January 19, 2023

Re: Permit No. M-1980-244; Cripple Creek & Victor Gold Mining Company; Cresson Project;
Technical Revision 130 – Fourth Adequacy Review Response

- PHASE IVc GEOMEMBRANE LIMITS 2004
- PHASE IVc BERM RAISE GEOMEMBRANE LIMITS 2012
- MILL SITE GEOMEMBRANE LIMITS 2013
- MILL SITE EARTHWORK LIMITS 2013
- MINOR CONTOUR
- MAJOR CONTOUR
- GCL MATTING

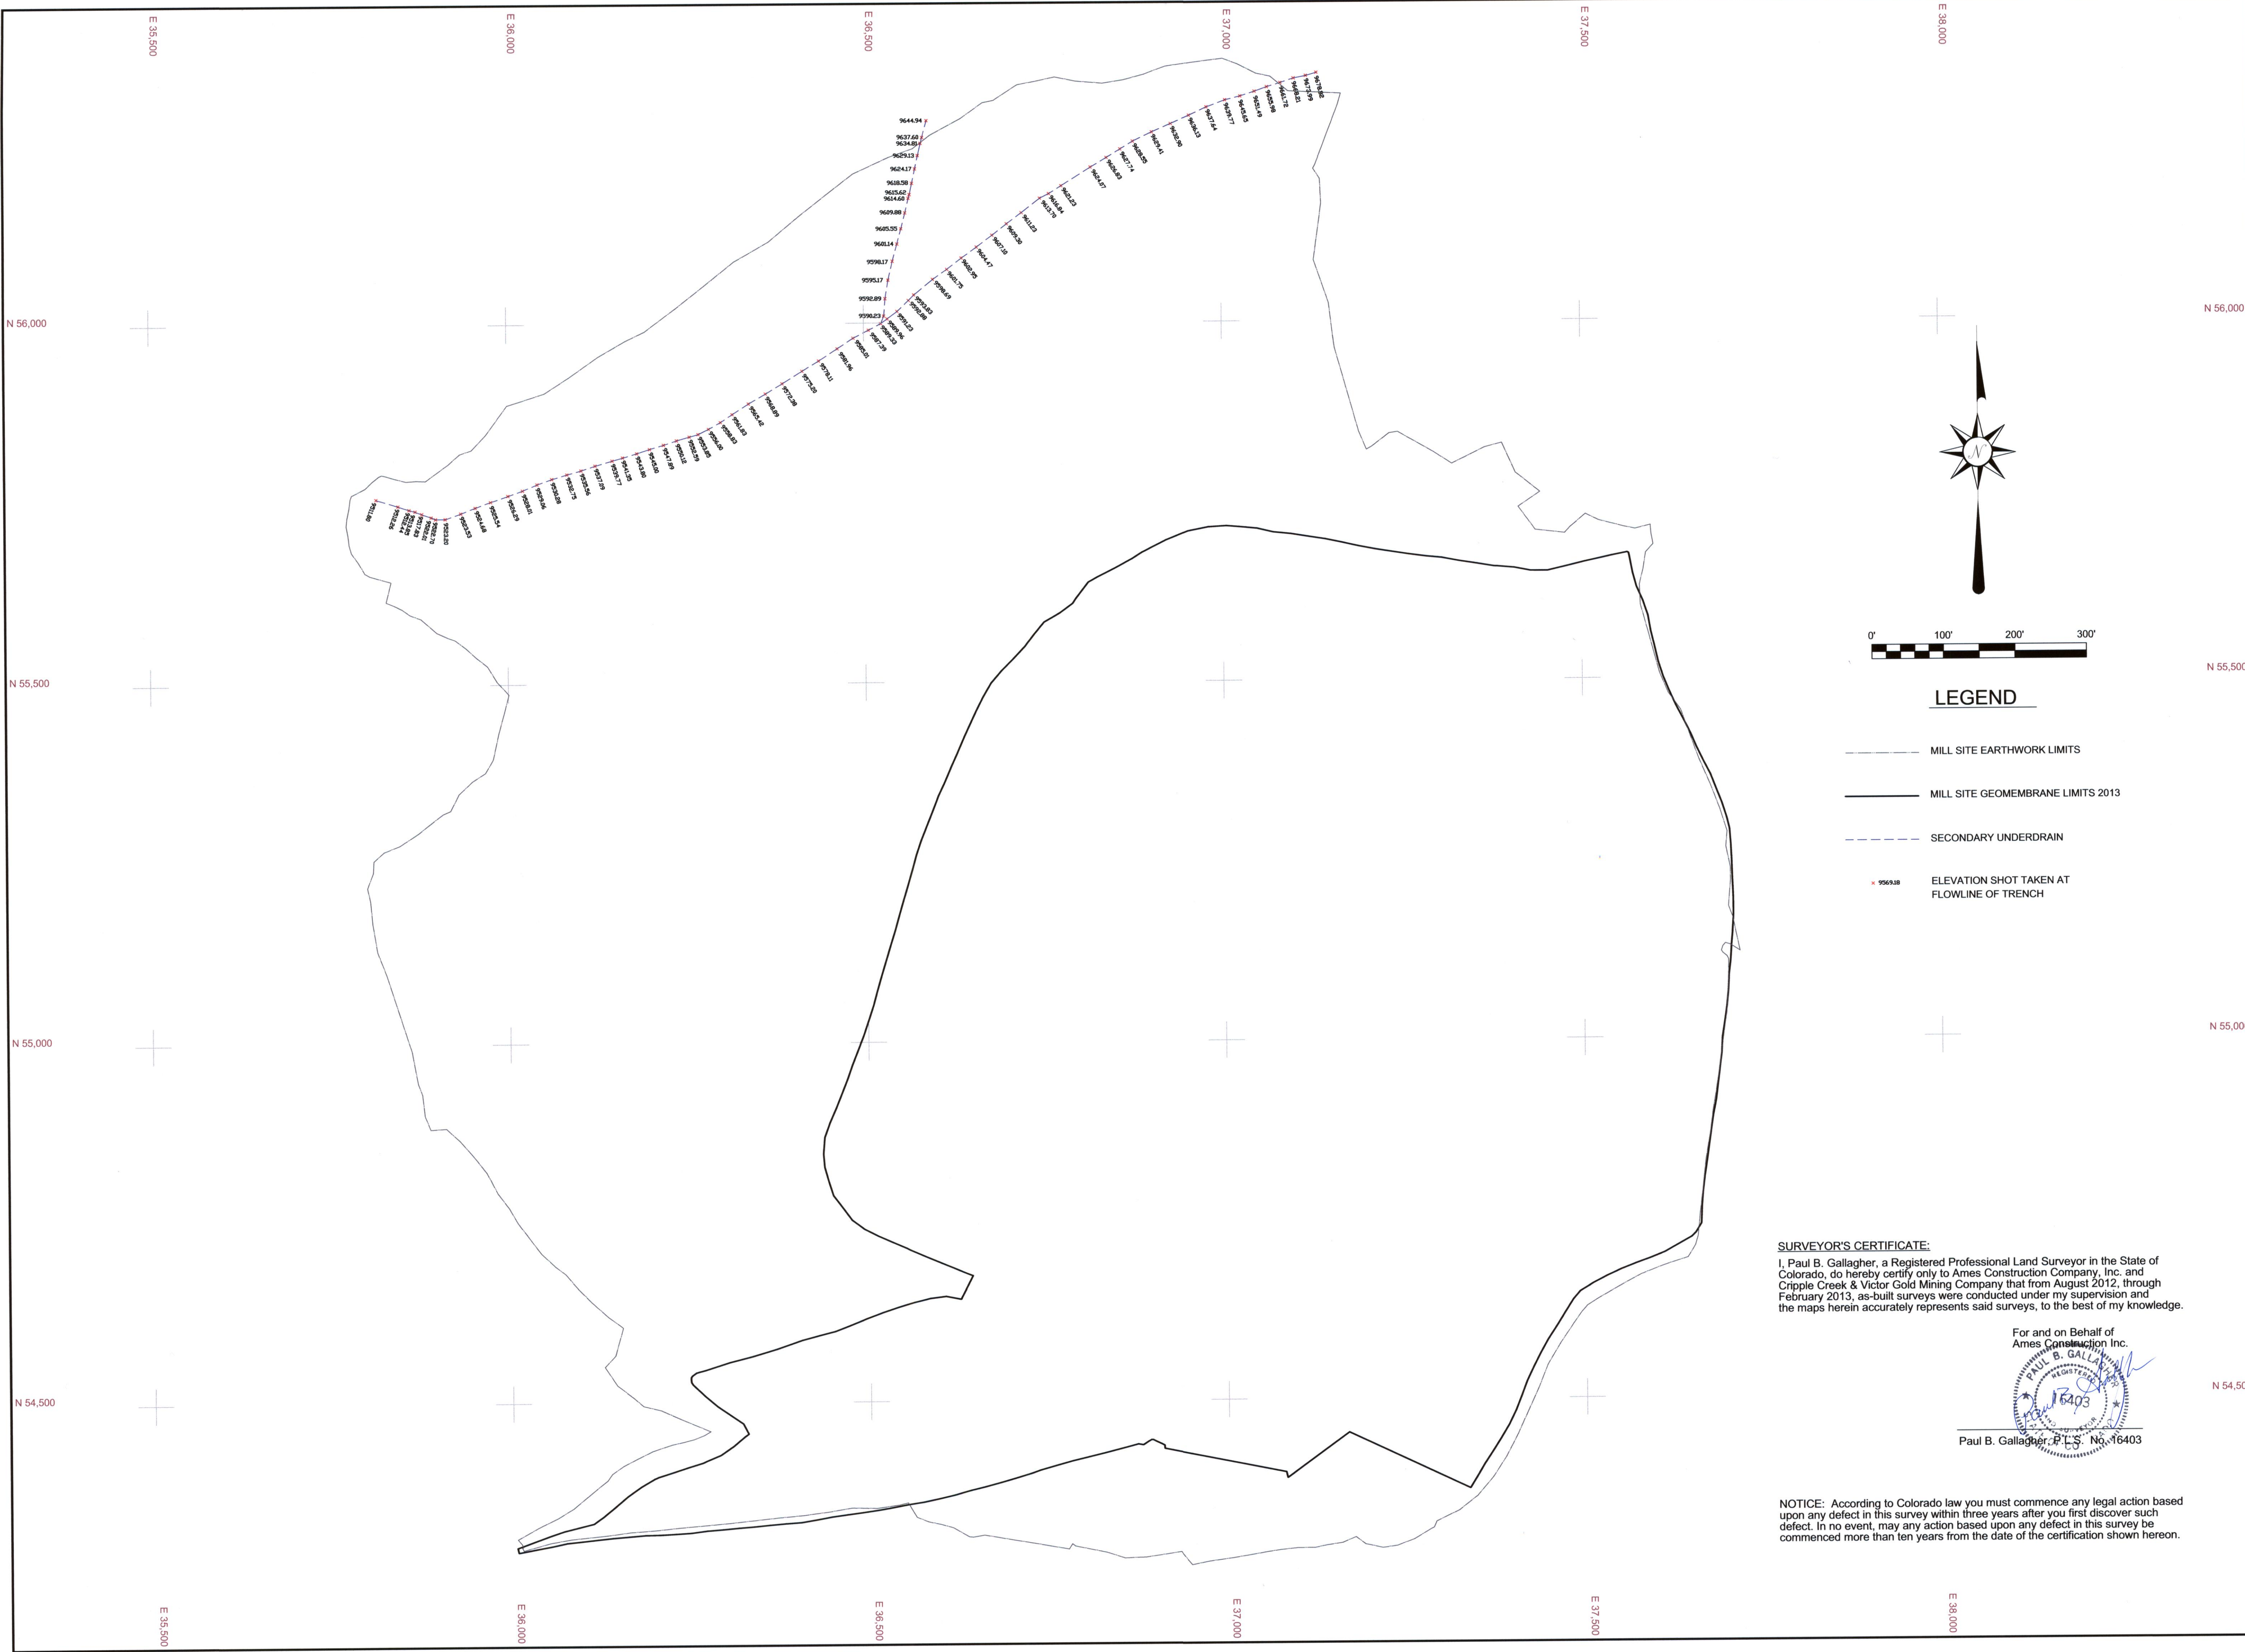
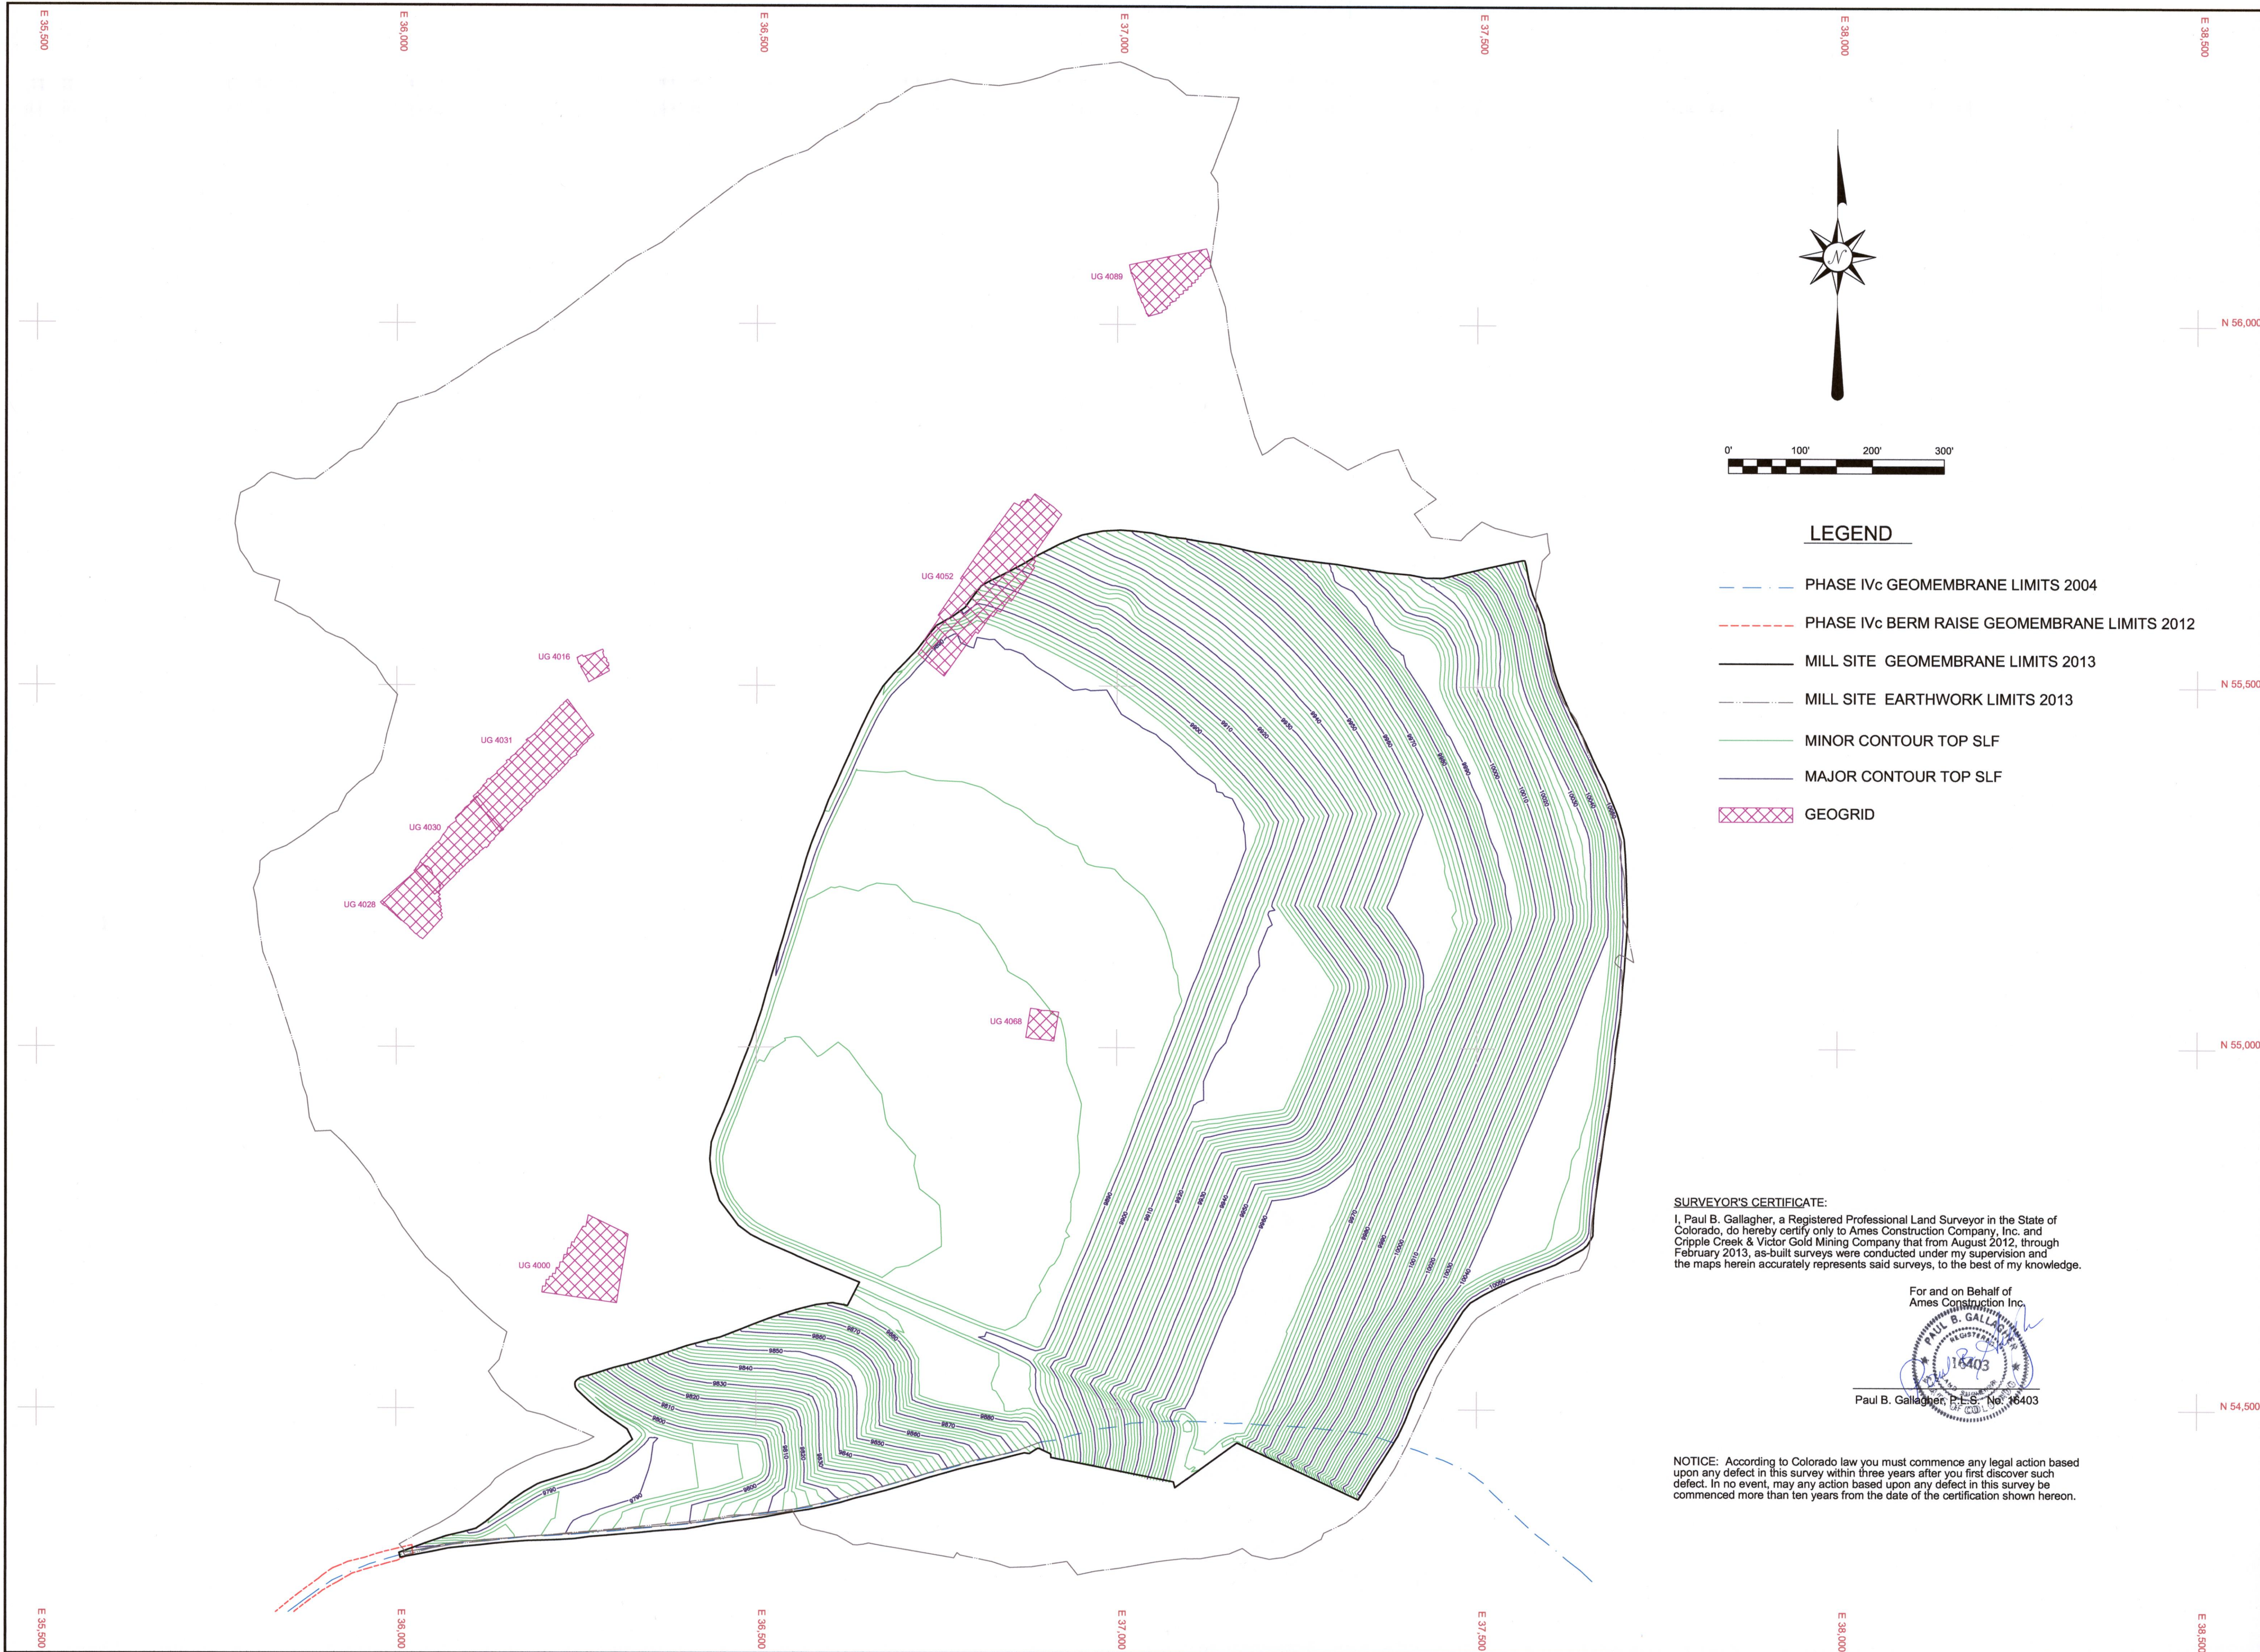
- i. **Provide As-Constructed drawings showing the layout and topography of the lined surface. This should show the storage volume, floor and sill elevations, and how it ties into adjacent lined areas,**
Please see the attached.

T A170 MILL PLATFORM SUMP SECTION
NTS

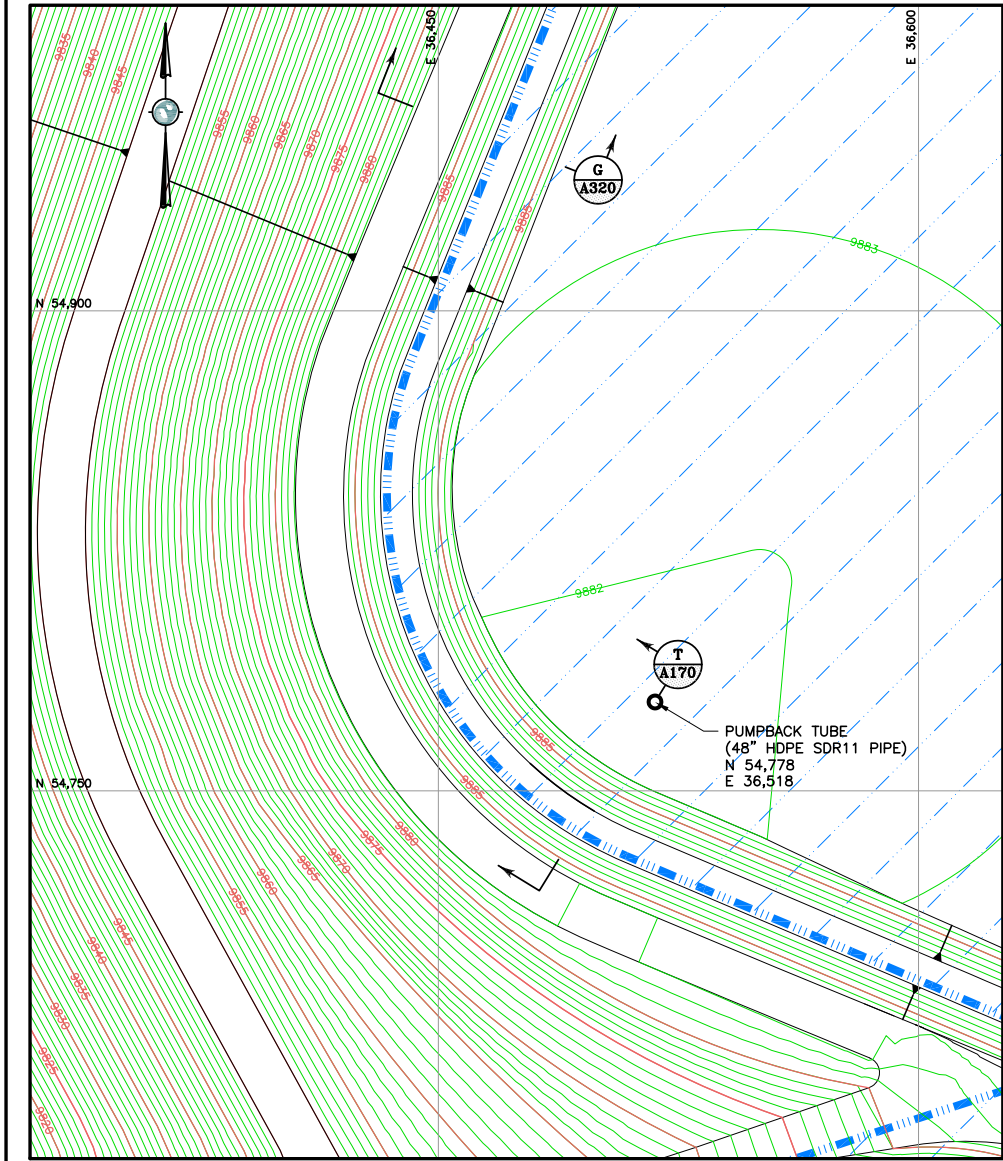
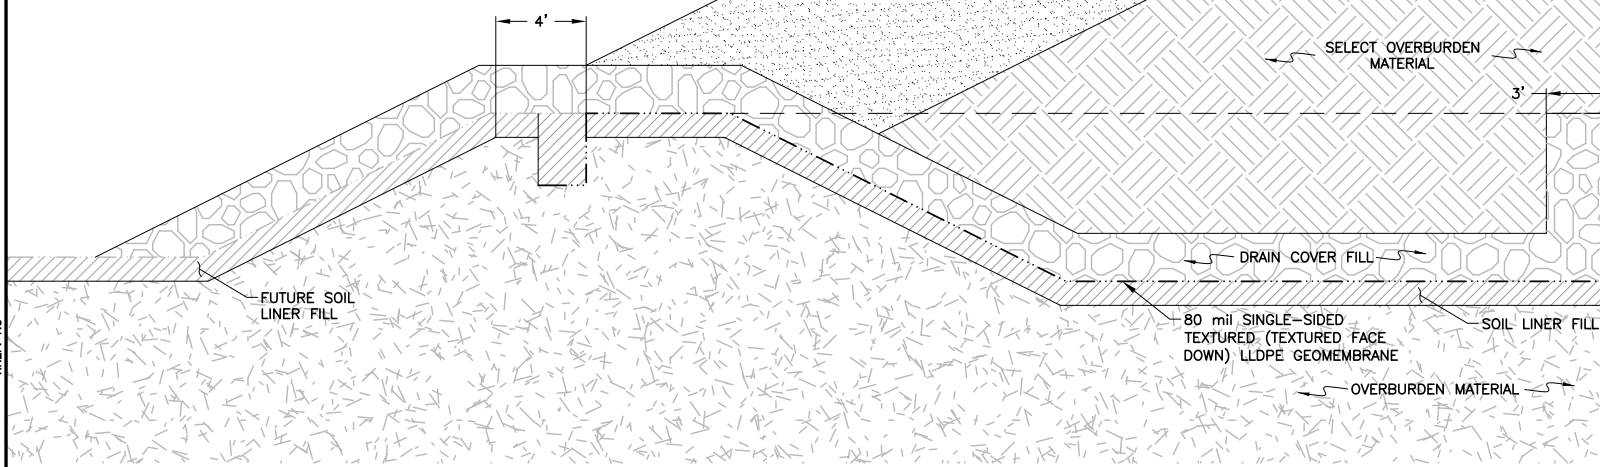
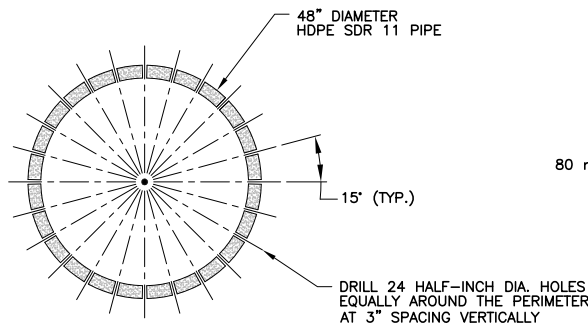
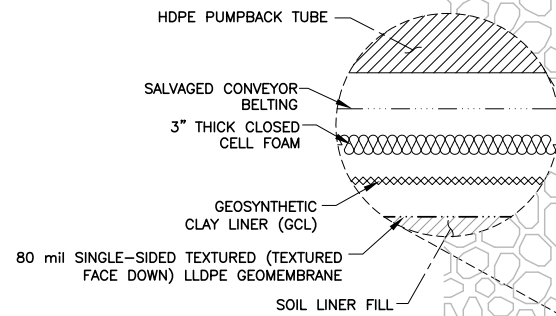
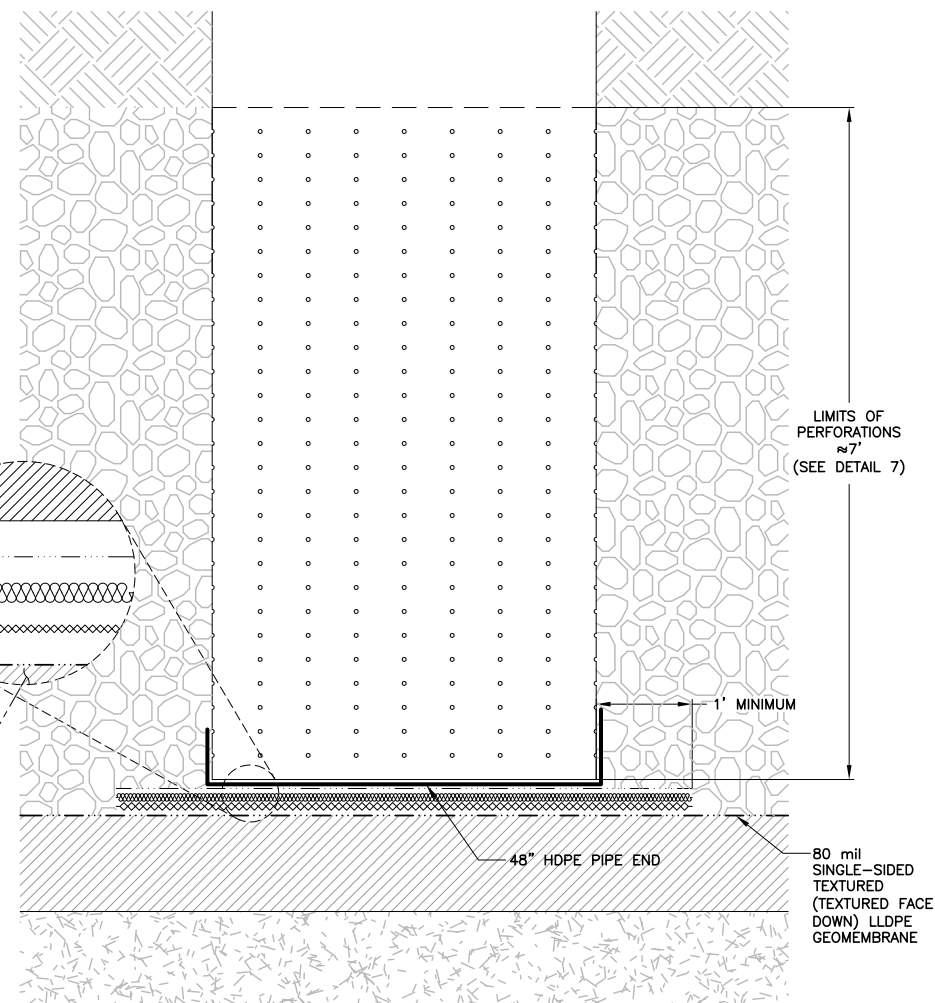
- ii. **Provide As-Constructed drawings showing how the sump system is integrated into the HGM liner (this should also identify new or proposed appurtenances required to manage stormwater as a results of TR-130,**

As-Constructed drawings could not be obtained that show how the sump system is integrated into the HGM liner. This was discussed during a meeting with DRMS and CCV on January 3, 2023.
